**Economic and Social Council**Distr.: General
19 December 2019

Economic Commission for Europe**Inland Transport Committee****World Forum for Harmonization of Vehicle Regulations****180th session**

1958 Agreement:**Consideration of draft amendments to existing****UN Regulations submitted by GRSG****Proposal for Supplement 1 to UN Regulation No. 151 (Blind Spot Information Systems (BISIS))****Submitted by the experts from the Working Party on General Safety***

Supplement 1 to UN Regulation No. 151 (Blind Spot Information Systems (BISIS))

Appendix 1, Figure 1, amend to read:

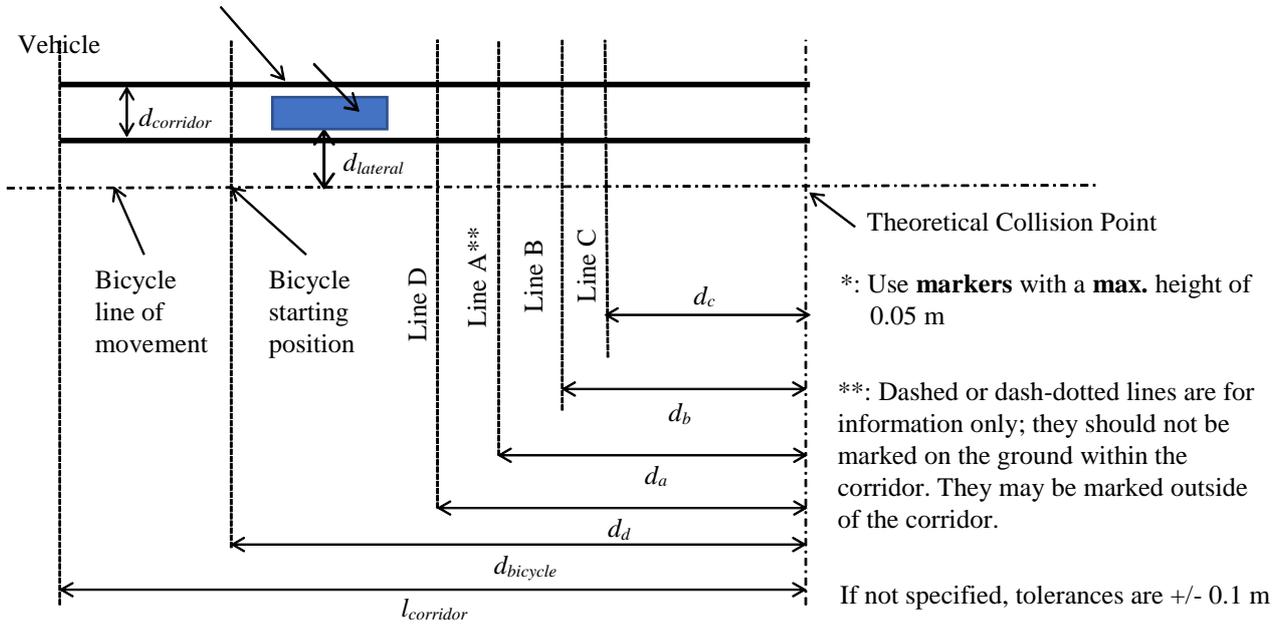
Mark corridor using markers *, spacing not more than 5 m
